# EAST TOWN CROSSING FRONTAGE IMPROVEMENTS

## COVER SHEET

# EAST TOWN CROSSING SHAW ROAD IMPROVEMENTS

EAST TOWN CROSSING PIONEER WAY IMPROVEMENTS  
SEC. 26,35/ TWP. 20 N./ RGE. 4 E., W.M.

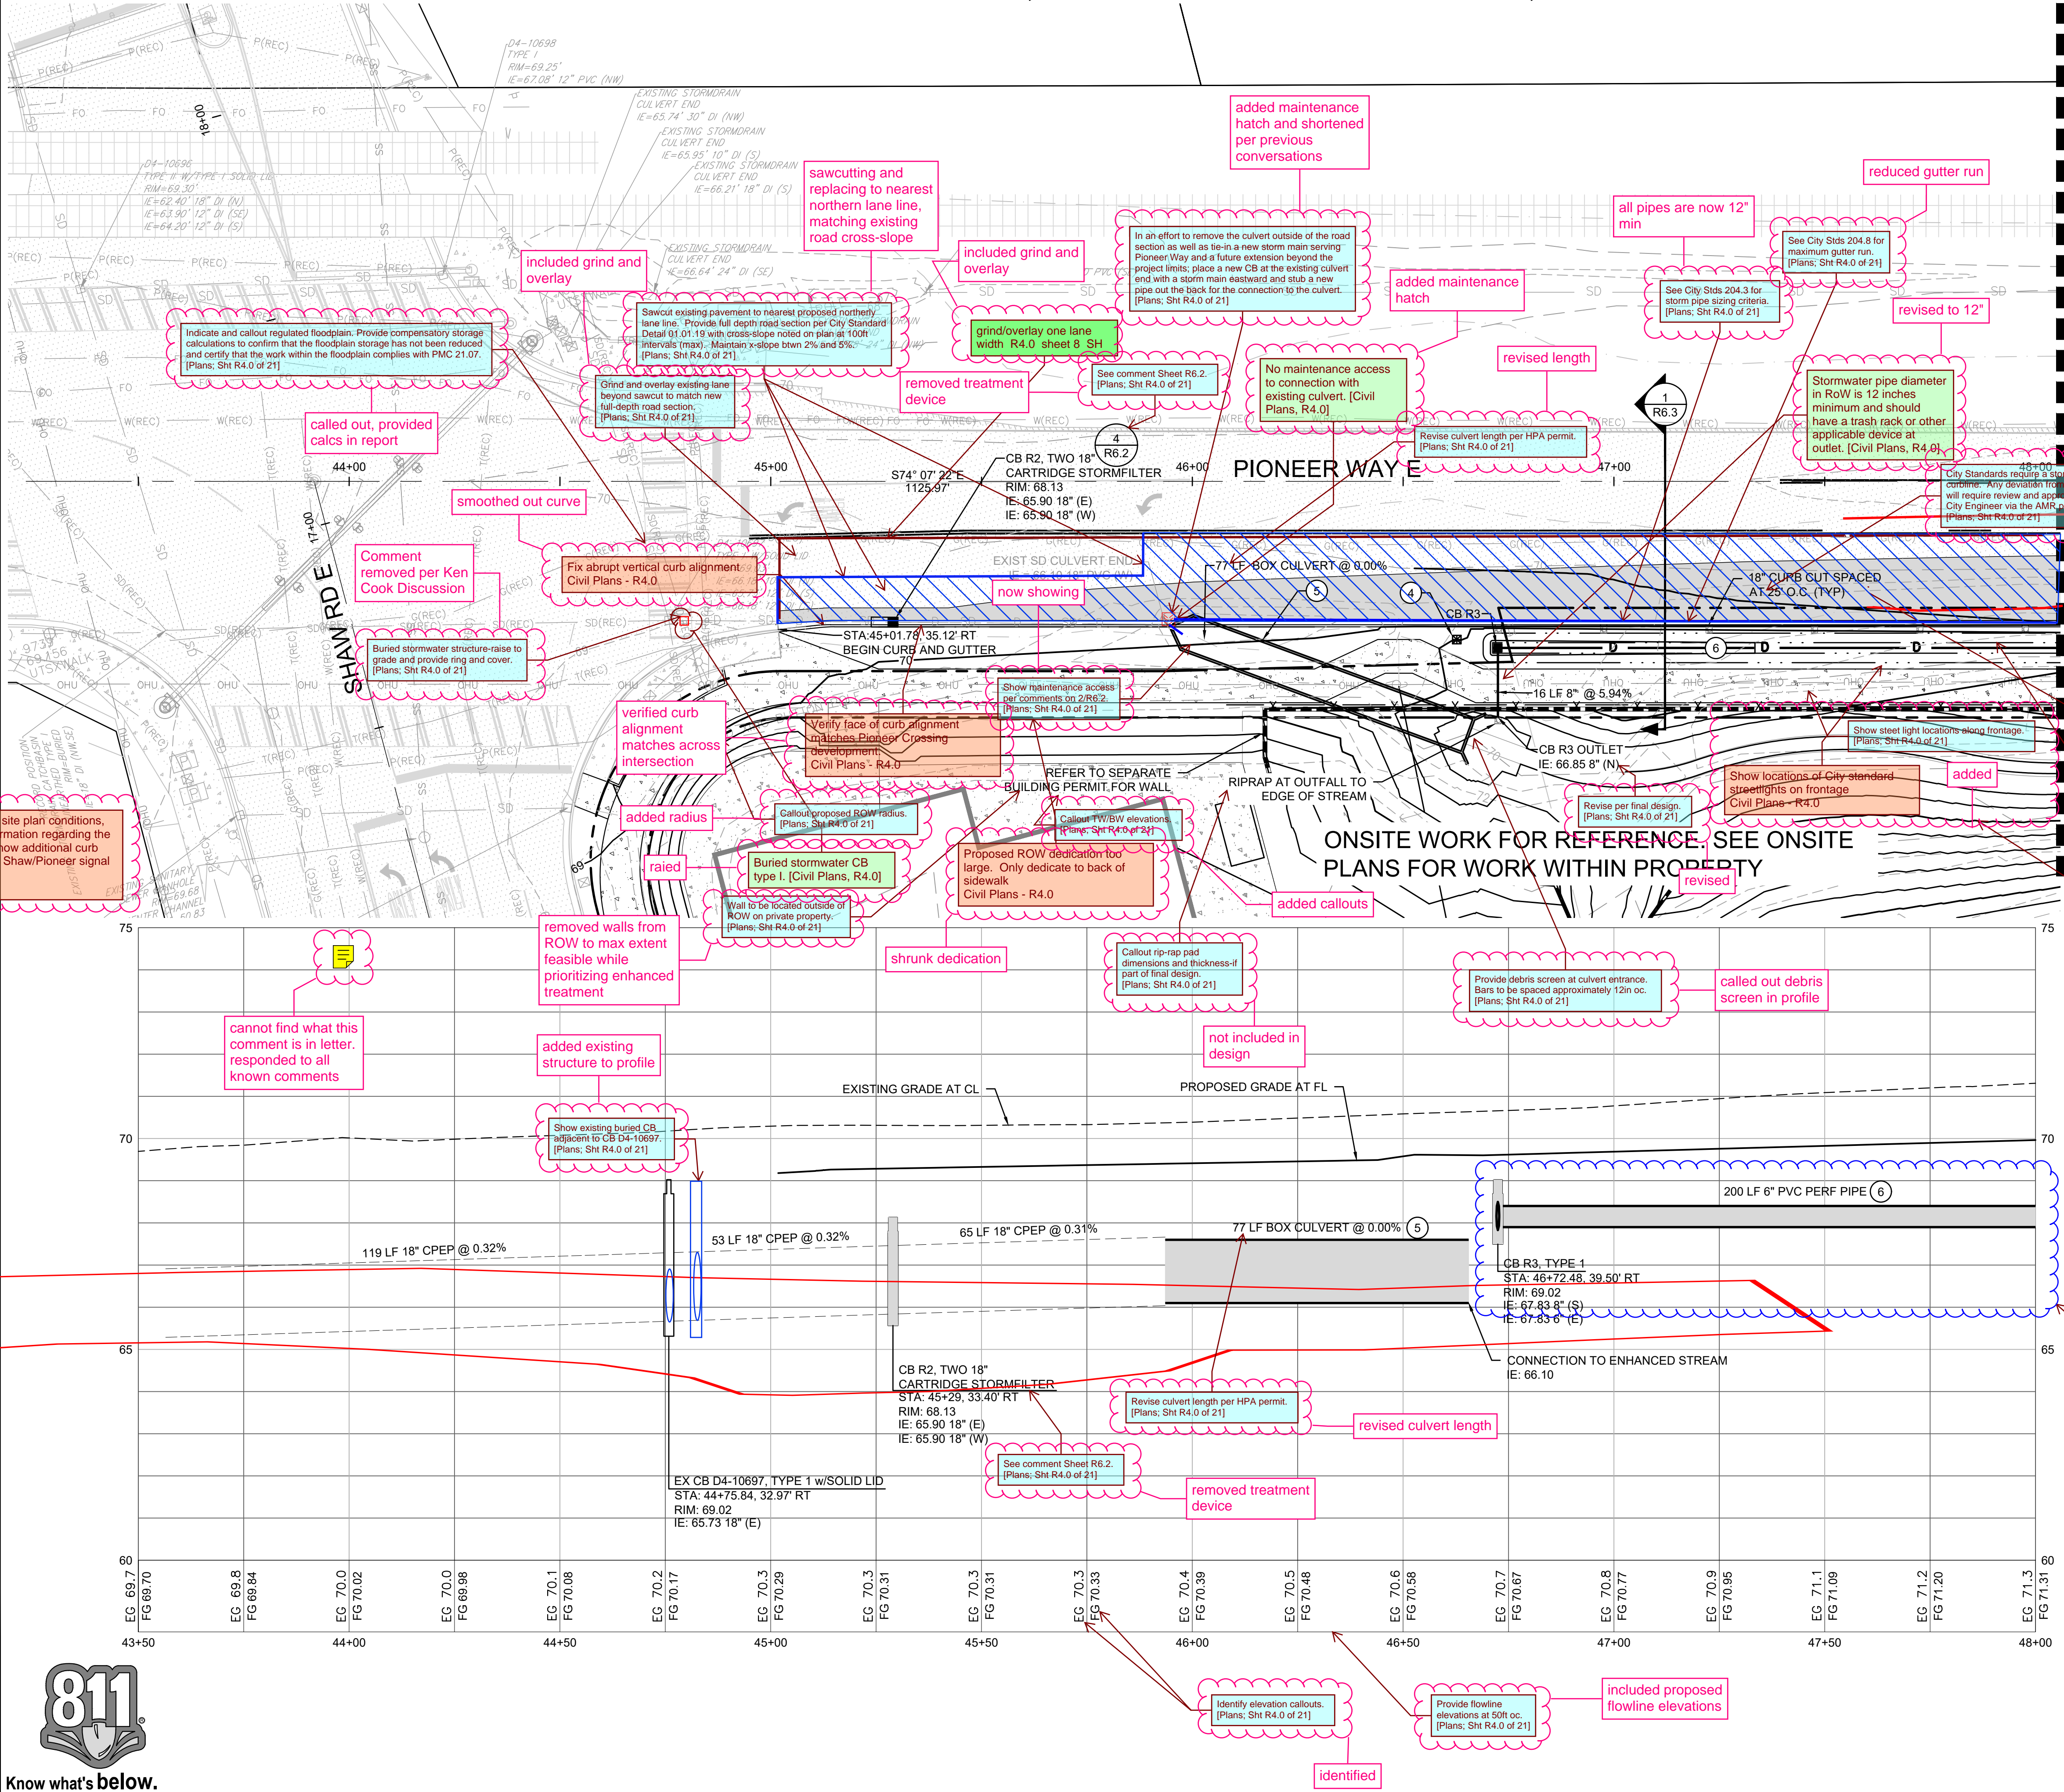
Proposed voids in vertical curb is not allowed. Must propose a design alternative that provides a continuous vertical curb along arterial segment. Civil Plans - R4.0

The proposed biofiltration swale only provides Basic Treatment. Enhanced Treatment is required due to discharge to the regulated stream. Revise VWD design accordingly. [Plans: Sht R4.0 of 21]

Callout contour elevations. [Plans: Sht R4.0 of 21]

Revise for Enhanced Treatment. [Plans: Sht R4.0 of 21]

revised for enhanced treatment

Sheet No.  
**R5.0**  
10 of 21 Sheets

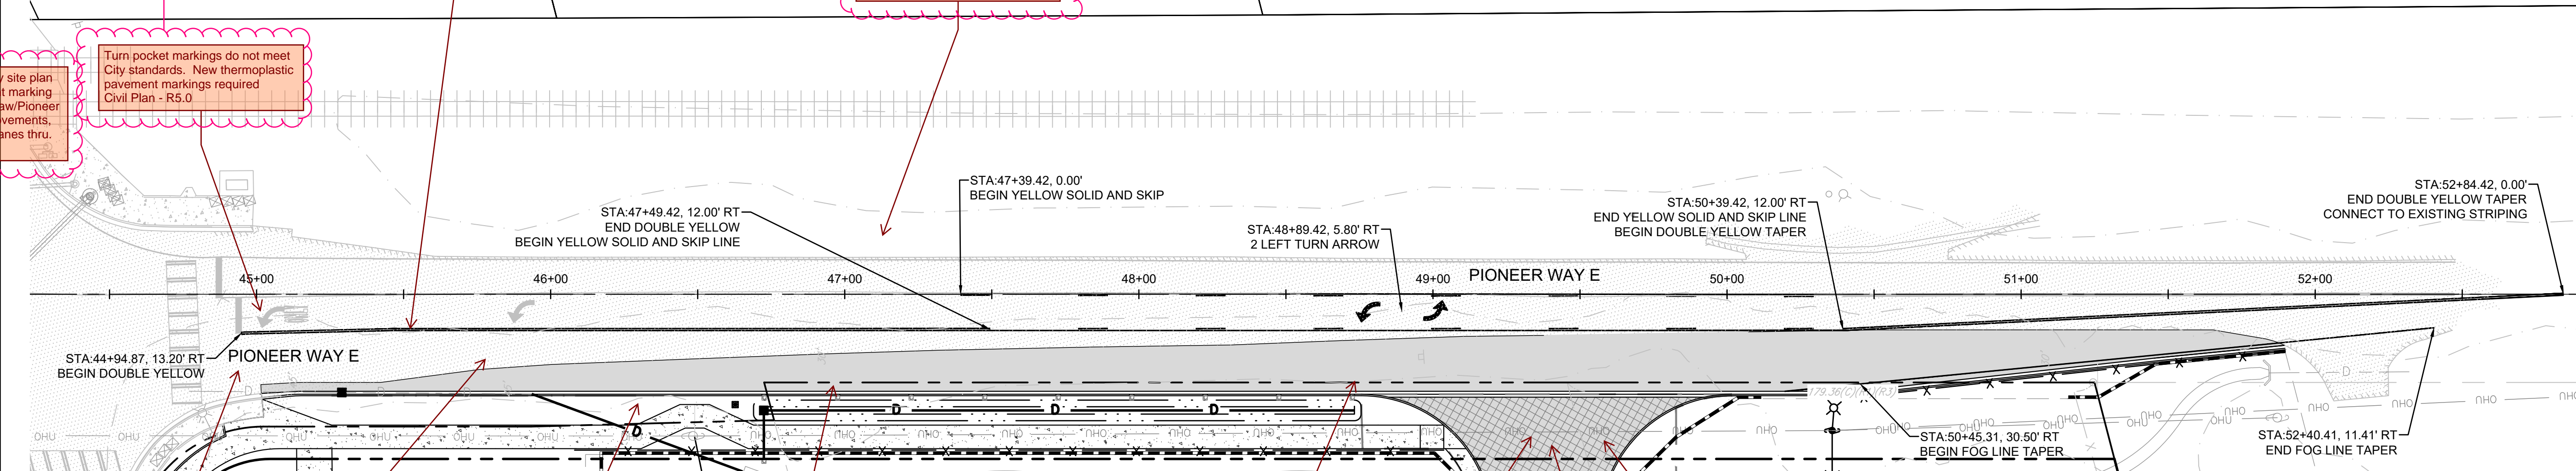
Prior to Occupancy, execute and record  
"Private Road Maintenance Agreement" (for  
maintenance of private striping within the  
ROW) on form approved by the City Attorney.  
[Plans; Sht R5.0 of 21]

Channelization?  
Civil Plans - R5.0

Provide right turn pocket striping +  
arrows -  
Civil Plans - R5.0

Provide striping info for the approach.  
[Plans; Sht R5.0 of 21]

Two EB lane striping not provided  
Civil Plans - R5.0

Provide MUTCD compliant "RIGHT  
LANE MUST TURN RIGHT"  
signage  
Civil Plans - R5.0

Provide short interval white skip  
stripe in advance of solid white  
gore for right turn pocket  
Civil Plans - R5.0

Verify lane striping alignment with existing  
striping on the west side of signal.  
Civil Plans - R5.0

details for existing pavement  
marking removal should be on this  
sheet  
Civil Plans - R5.0

Per approved preliminary site plan conditions, civil plan set shall provide a detailed channelization  
plan for all striping & pavement markings in within ROW. All proposed striping shall meet City and  
MUTCD requirements. Plan shall include signage located in ROW. All City standard details  
related to pavement markings, striping, sign placement must be provided.  
Civil Plans - R5.0

Remove curvature  
Civil Plans - R5.0

Turn pocket markings do not meet  
City standards. New thermoplastic  
pavement markings required  
Civil Plan - R5.0

Per the approved preliminary site plan  
conditions, striping/pavement marking  
modifications required at Shaw/Pioneer  
signal. With proposed improvements,  
EB approach will allow two lanes thru.  
Civil Plans - R5.0

added

revised

R3-7 sign added

added

it lines up, showing  
across intersection  
so you can also verify  
if needed

added note to TESC

revised this sheet to  
meet that  
requirement

removed existing  
curve

updated

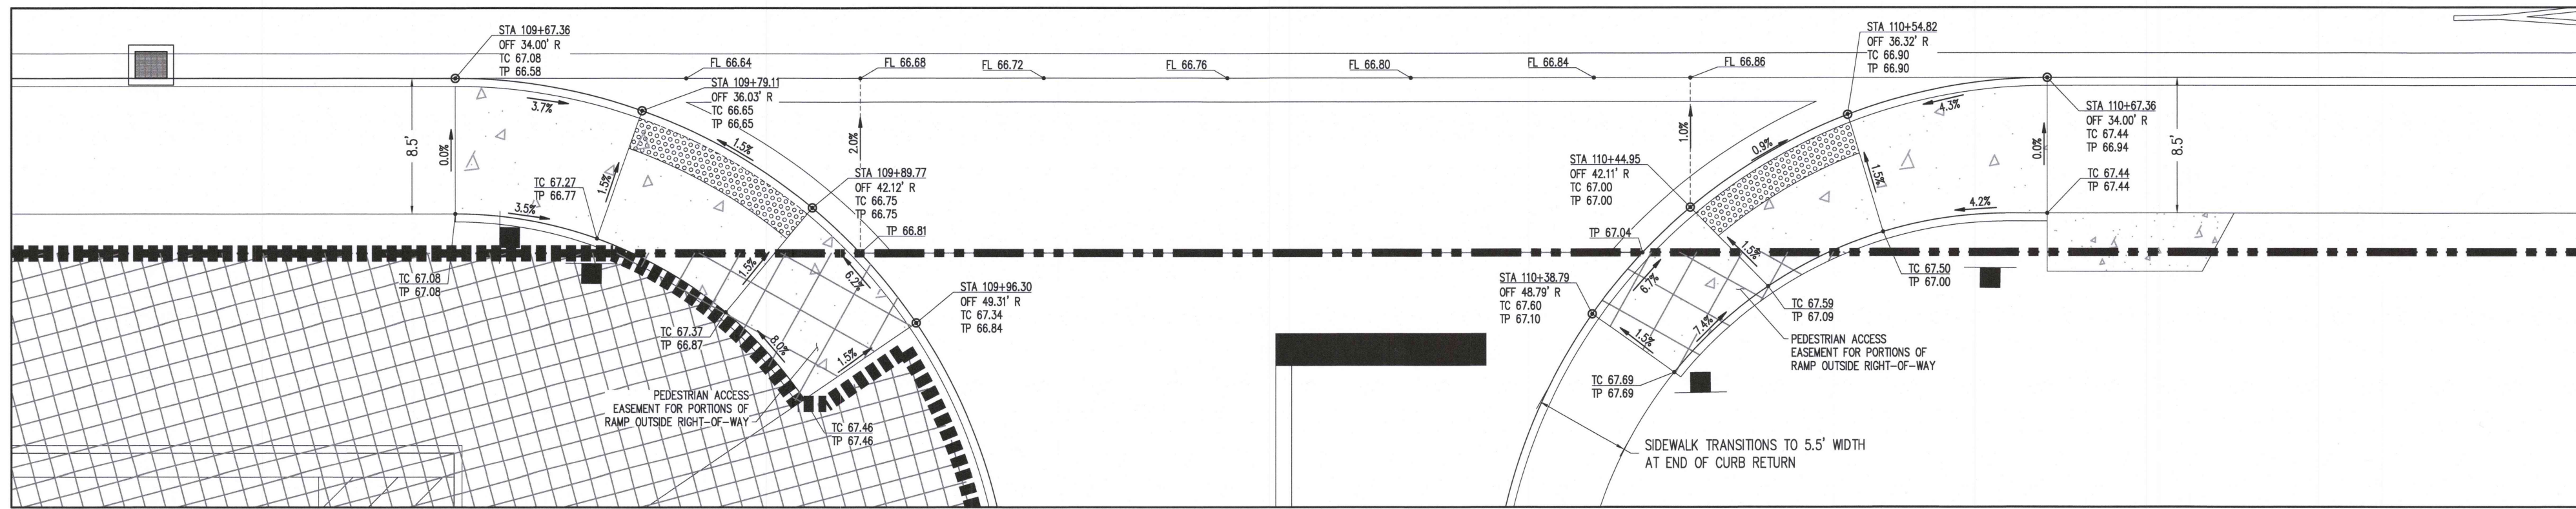
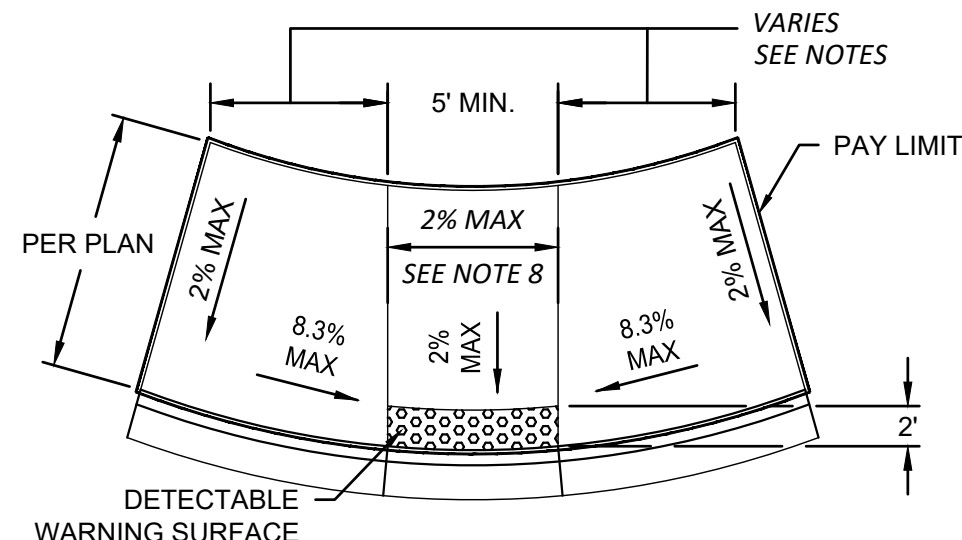
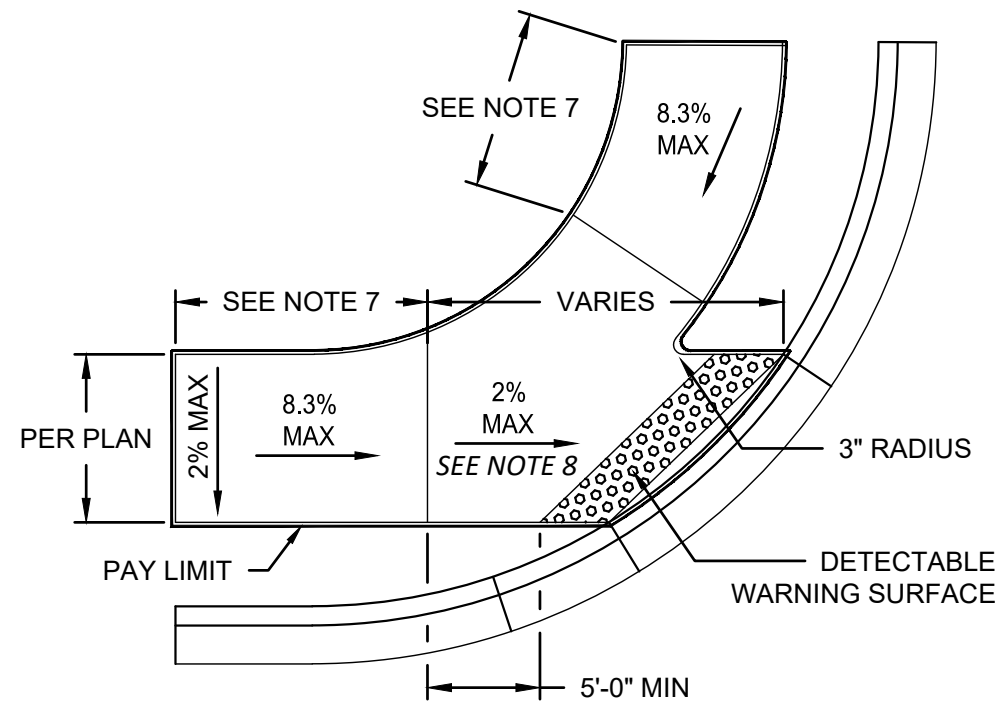
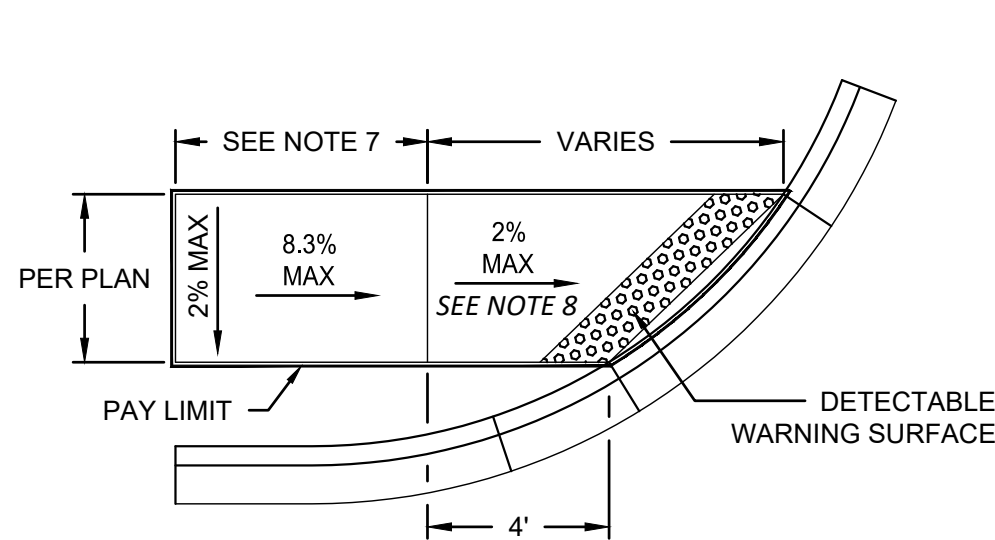
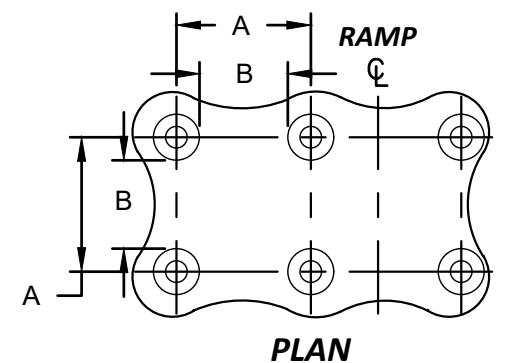
Remove reference to Pierce County standard. [Plans: Sht R6.1 of 21]

Notes 13 and 14 aren't applicable to this project. [Plans: Sht R6.1 of 21]

comment not in correction letter
